**LEE COUNTY HISTORIC PRESERVATION BOARD
OLD LEE COUNTY COURTHOUSE
2120 MAIN STREET
FORT MYERS, FL 33901
EAST ROOM**

AGENDA

A. COA 2011-00167 Wilson Residence, 16281 Quail Trail, Bokeelia, FL 33922

B. COA2011-00111, Goldpenny, 4725 Pine Island Rd, NW, Matlacha, FL 33993

LEFT ELEVATION 1/4" = 1'-0"

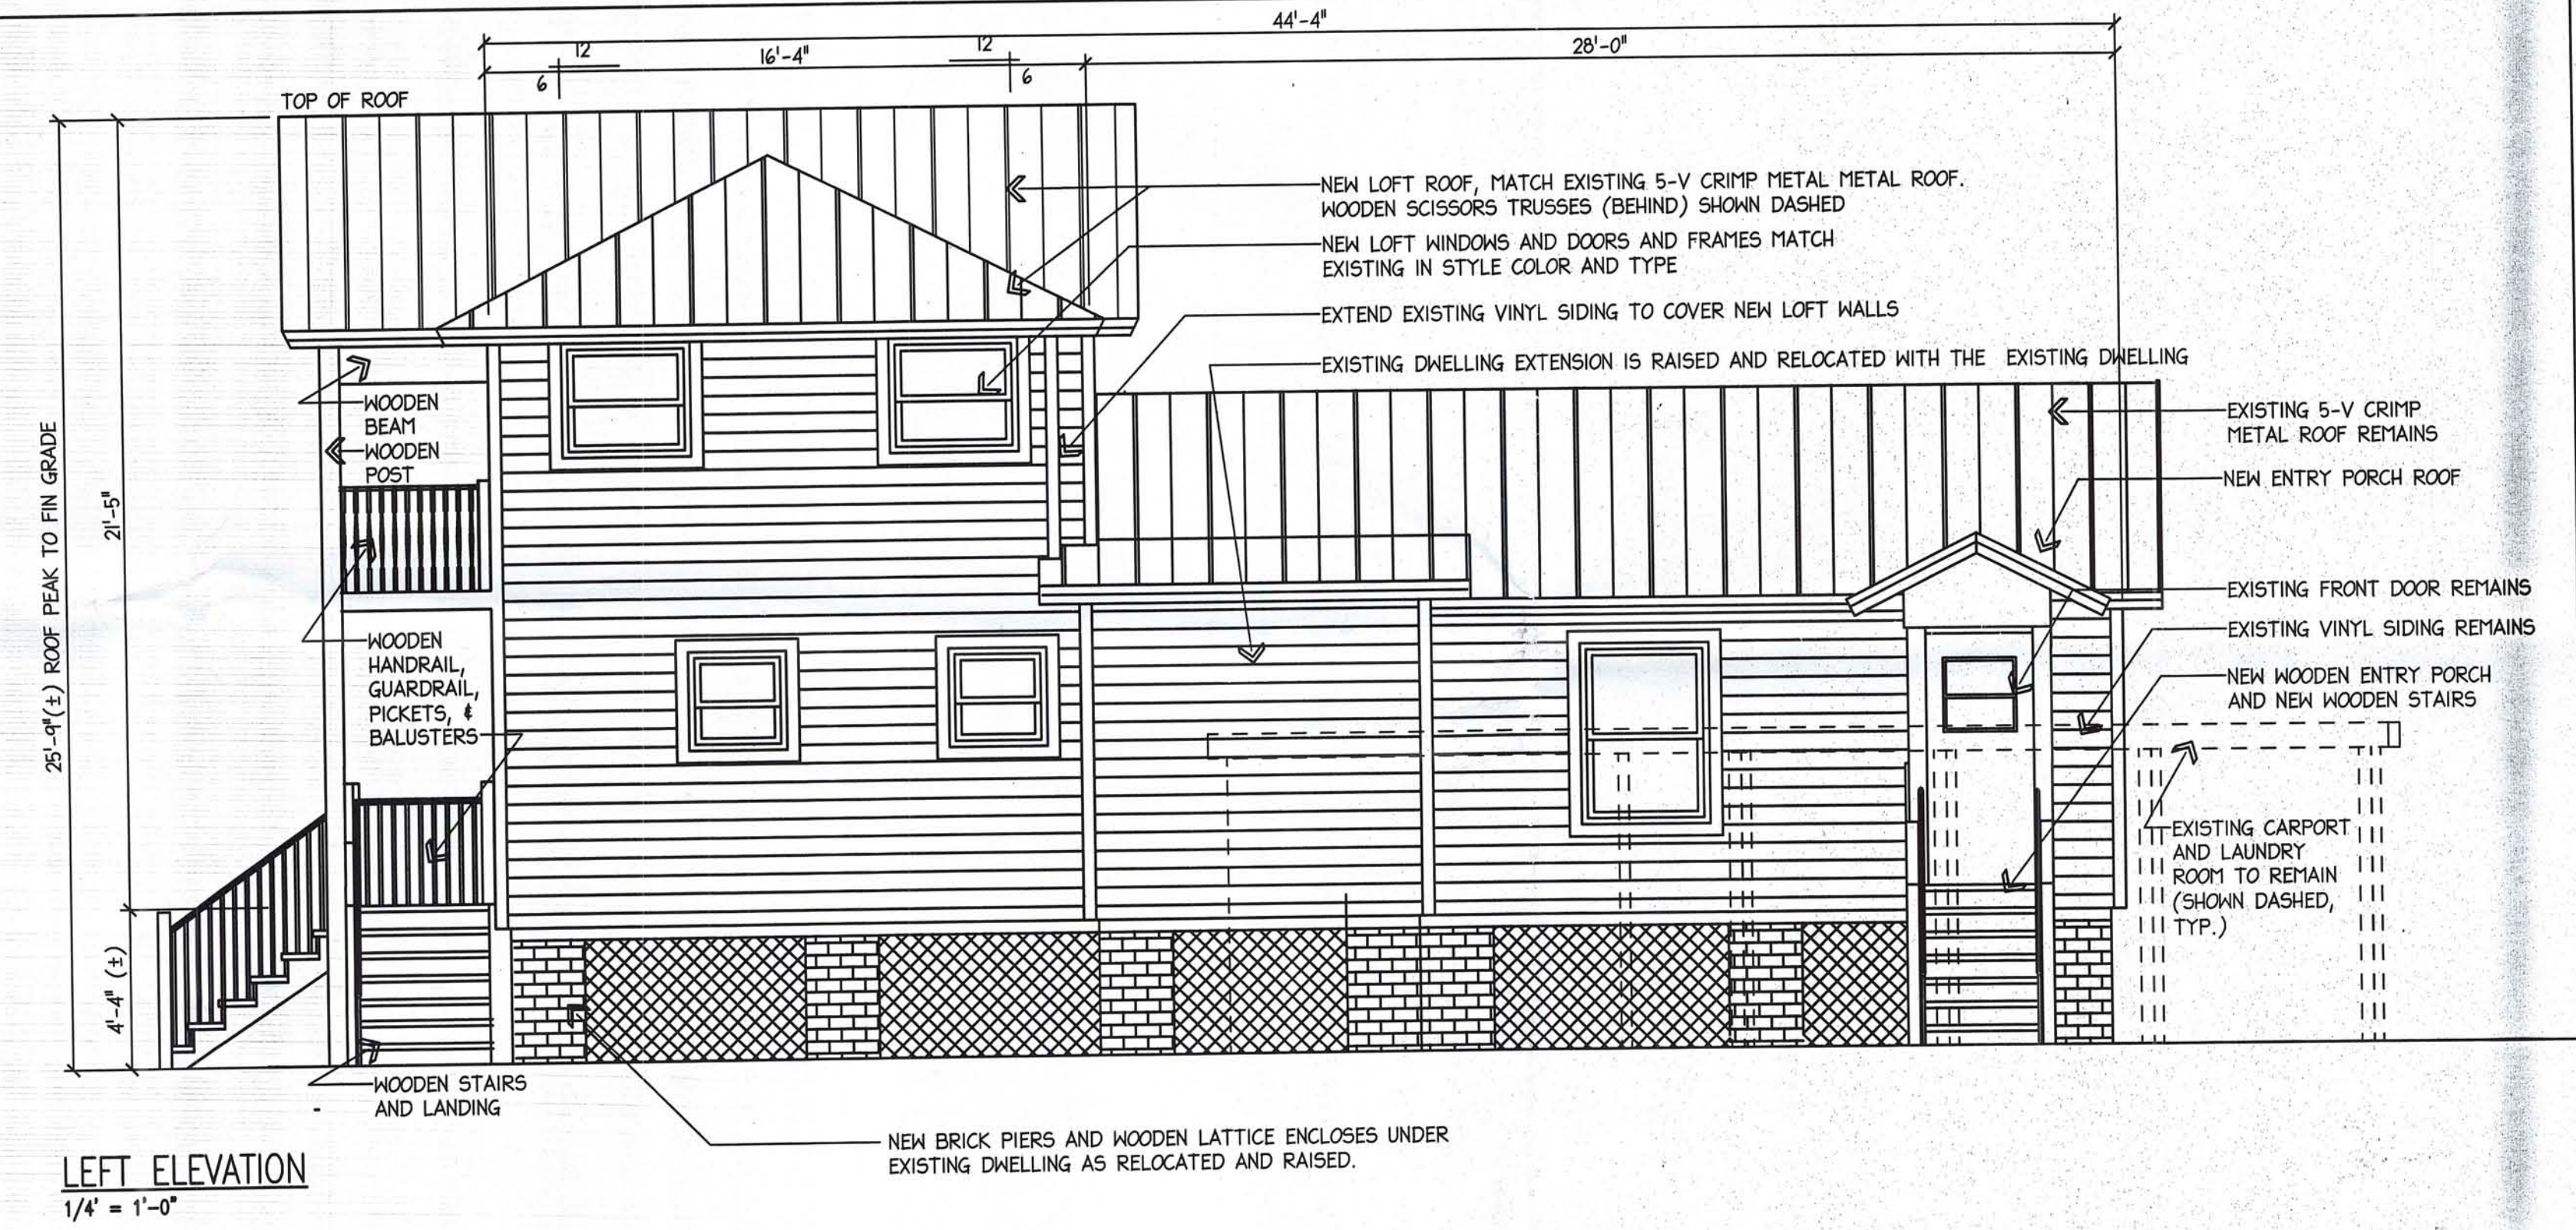
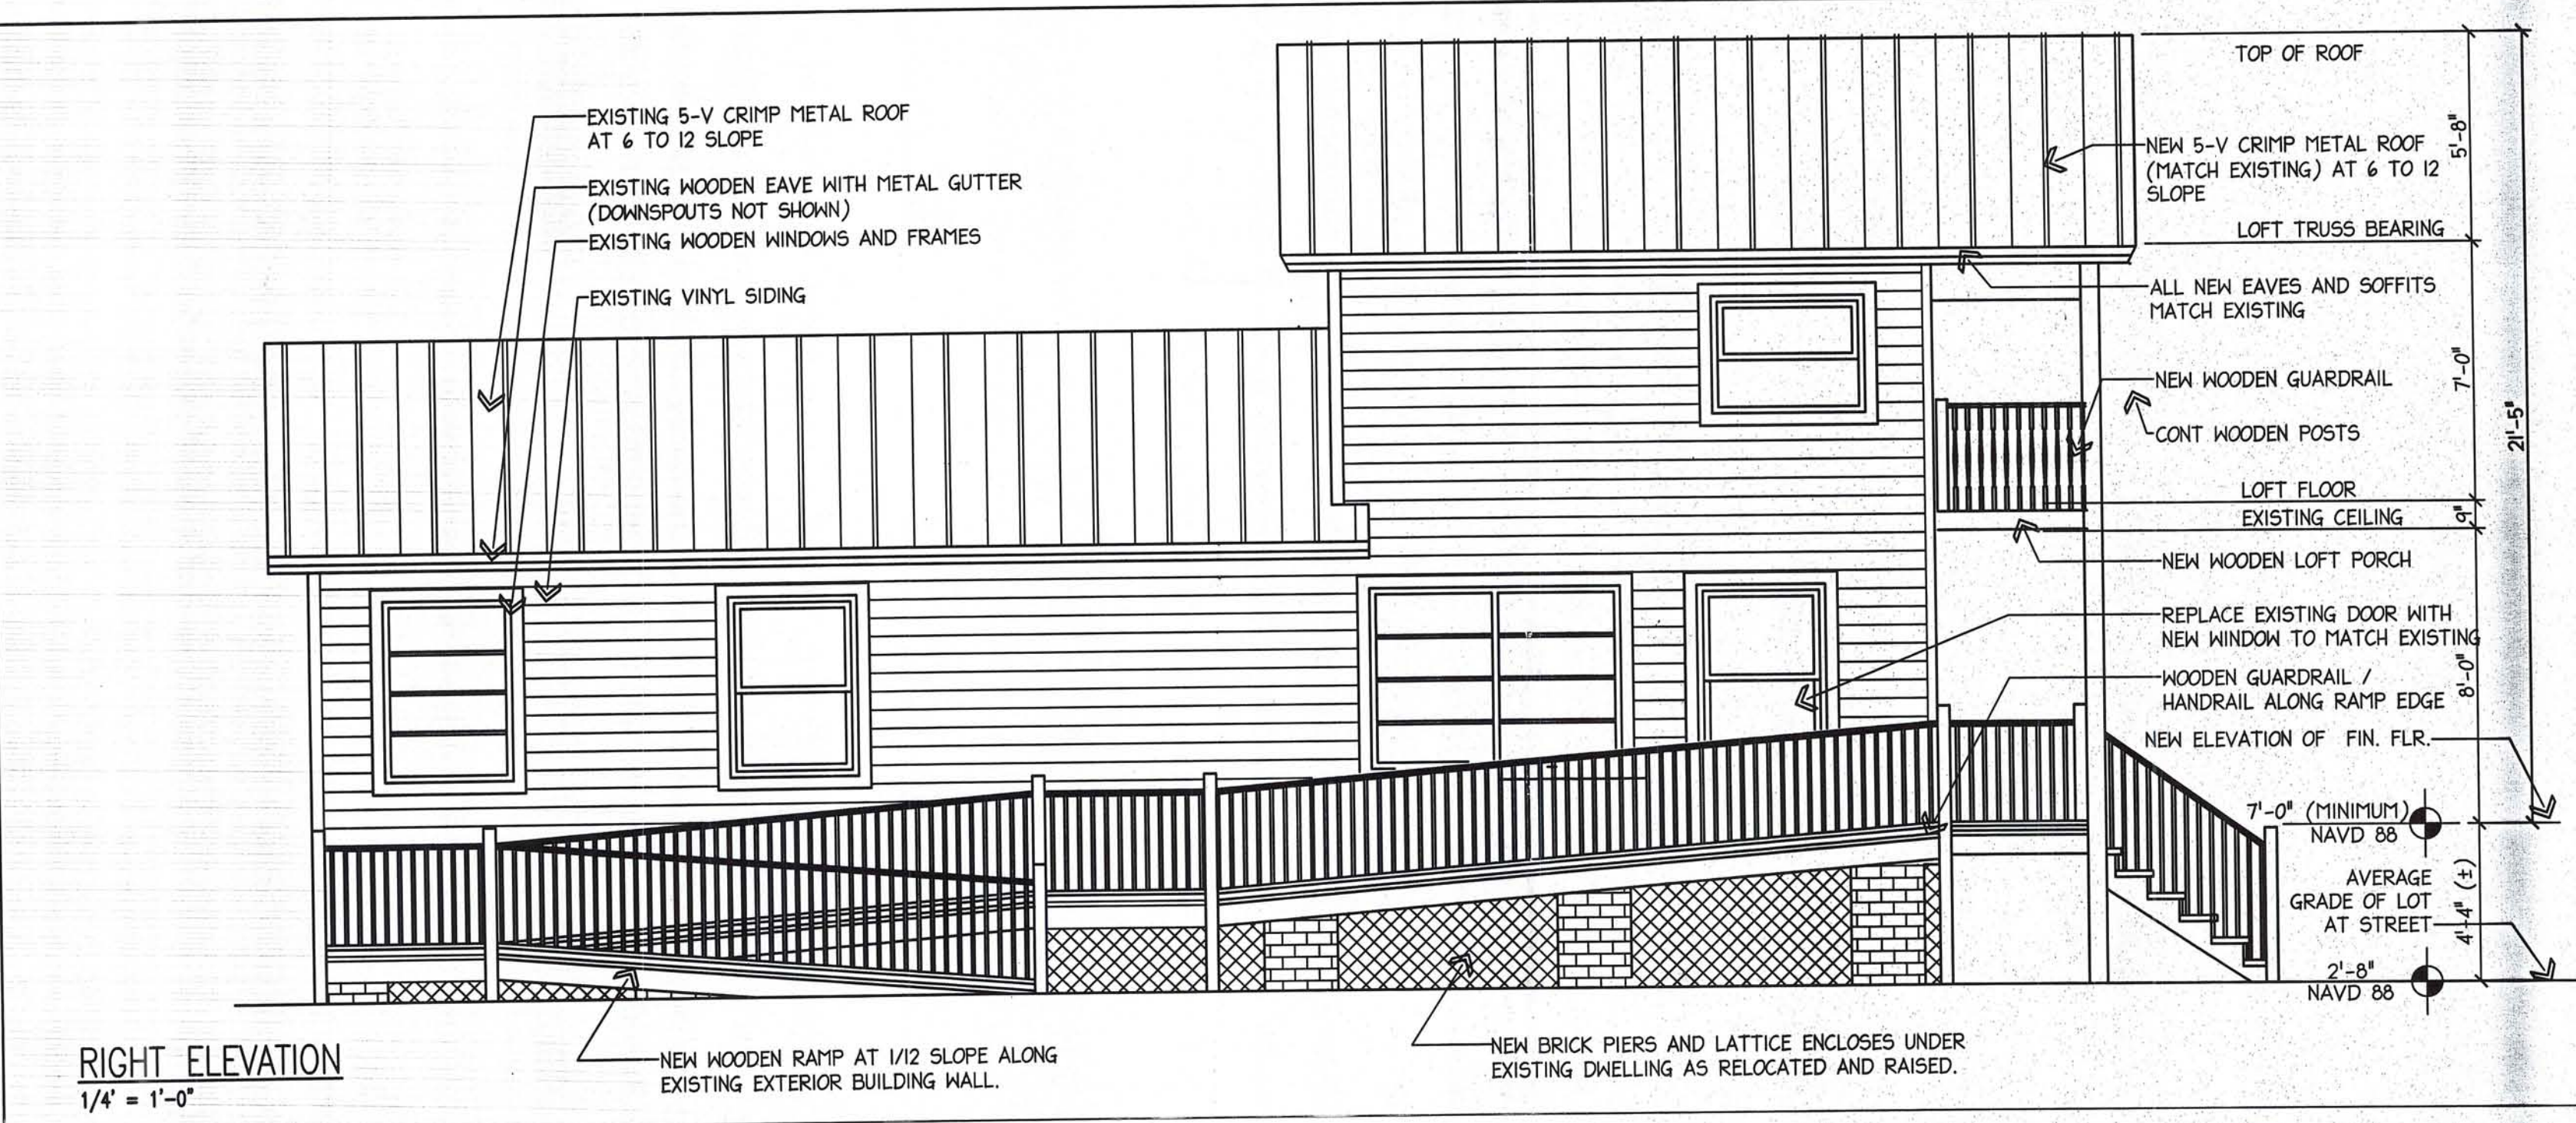
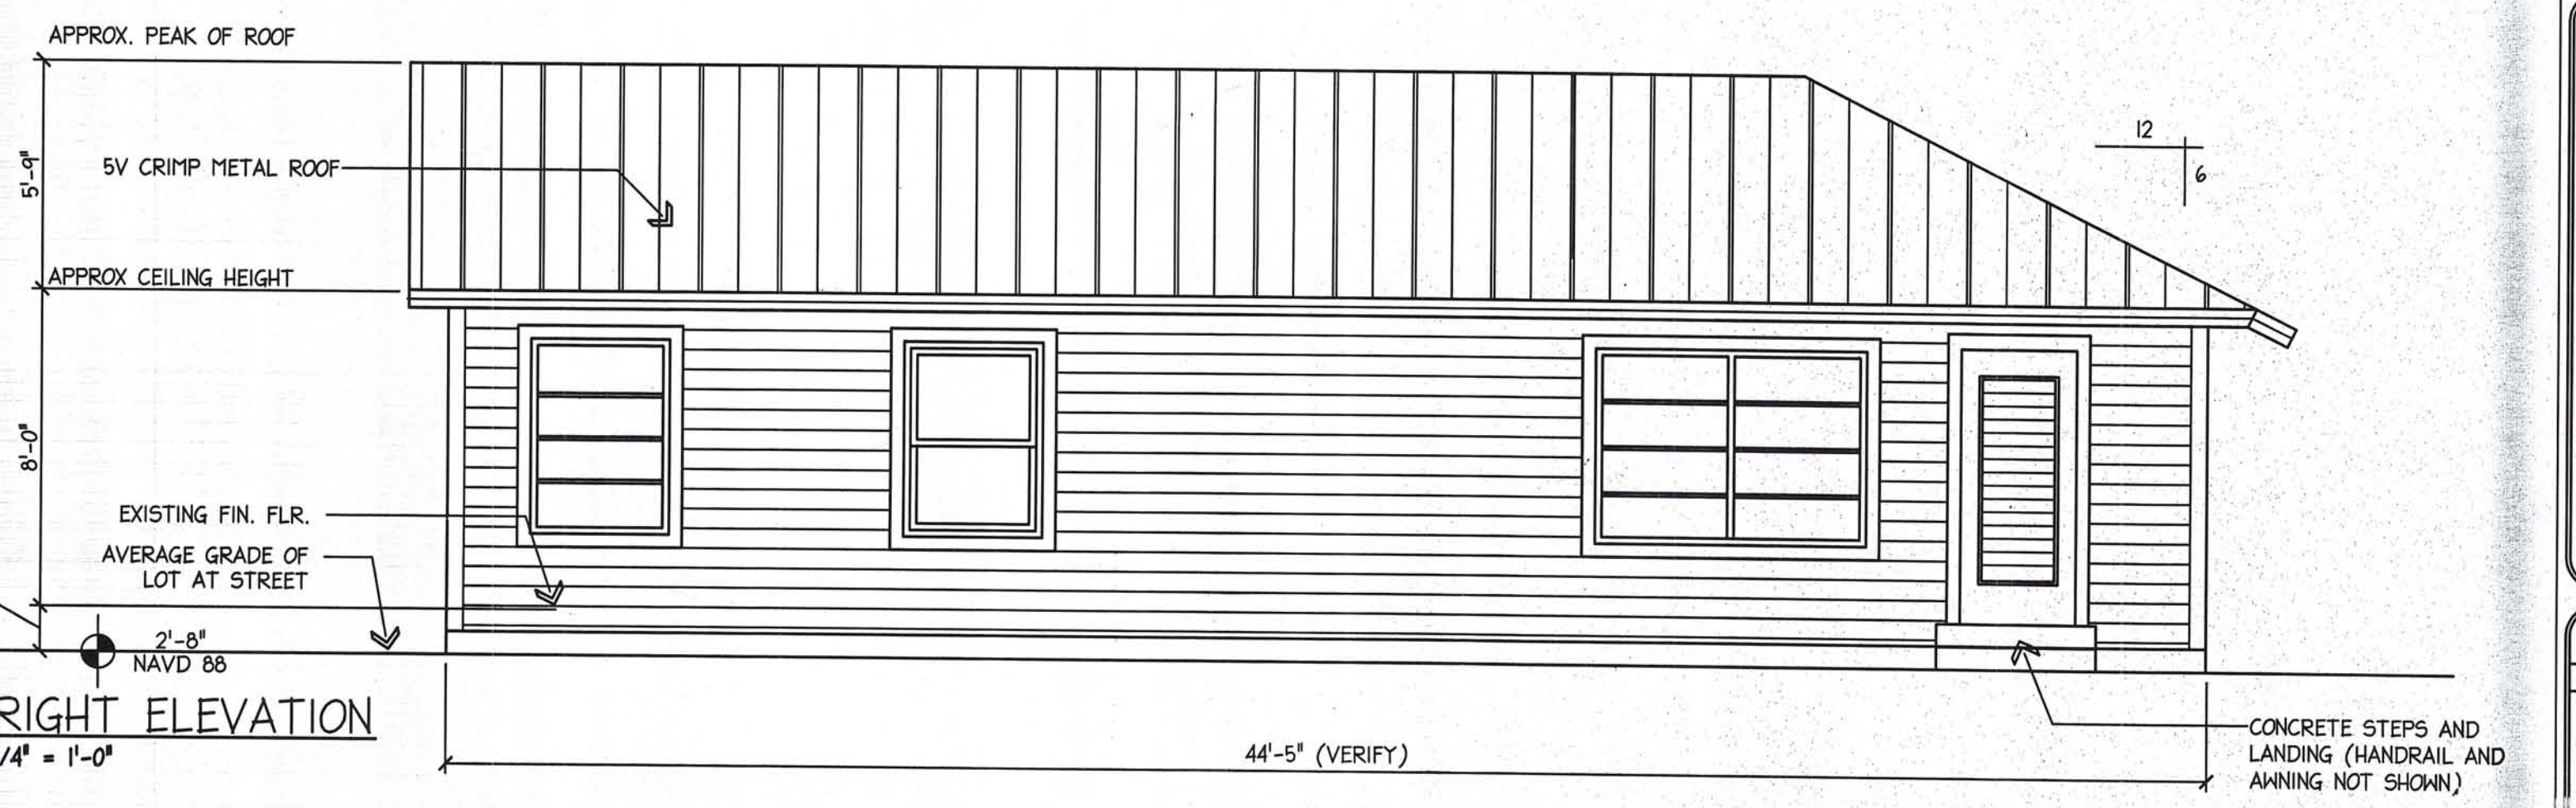
1. Relocation of the house on the site to increase the front setback area. Currently the house has a roughly 2-ft setback from the front property line along Pine Island Rd. The proposal would relocate the entire house as is and increase the setback from the front property line to 10-ft. The new increased setback would be in line with the setback of the adjoining property to the north. A larger front setback area would provide a greater, safer buffer between the house and Pine Island Rd. Safety is a consideration particularly given that the house will have to be handicap accessible. Staff supports this change.

2. Elevating the house from roughly 1-ft 2-in above grade to 4-ft 4-in above grade in order to meet flood elevation. The request is to raise the house by 3-ft 2-in above the current elevation. This would provide greater protection in case of flooding and make the house compliant with flood regulations – which would make it easier and less costly to obtain insurance. Most of the houses along Pine Island Rd in the Matlacha are at or a few feet above grade. Raising the house 3-ft 2-in is a relatively small increase. Overall the height of the house would still be in keeping with the height of other houses in the district and the house would have added protection from flood waters. The proposed change would increase the height of the house from roughly 14-ft 11-in from grade to roof peak to roughly 18-ft 1-in (or increase it from roughly 13-ft 9-in from finished floor to roof peak to roughly 16-ft 11-in)

The elevated house would feature new brick foundation piers with lattice infill between the piers. This type of foundation design is typical of the vernacular houses found in Lee County and in Matlacha. Due to the installation of the handicap ramp (see below) the door towards the rear on the south side will be removed and replaced with a window. Staff supports this change.

While the applicant has tried to minimize the impact of the second floor addition, staff objects to the addition because it will substantially alter the massing, size and scale of the building. The house is a small single story building which at some point in time had slight additions to the rear and north side elevations. Adding a second story would radically change the original design of the building.

There is no compelling reason to add a second story to the building. The house sits on one of the larger lots in the Matlacha Historic District and the house could easily be enlarged by 401 sq ft by placing an addition at the first floor level.

The second floor addition at the rear is not recommended for approval as it involves not a minimal change but a drastic change to the single story design of the house, which is a defining characteristic of the building. Also the addition of a second story would be a substantial change to the environment of the building. The environment of this building is the Matlacha Historic District along Pine Island Road and in the vicinity of the subject property. (See attached photographs) This area of the district predominantly composed of small, single story buildings. This proposal does not meet this standard.
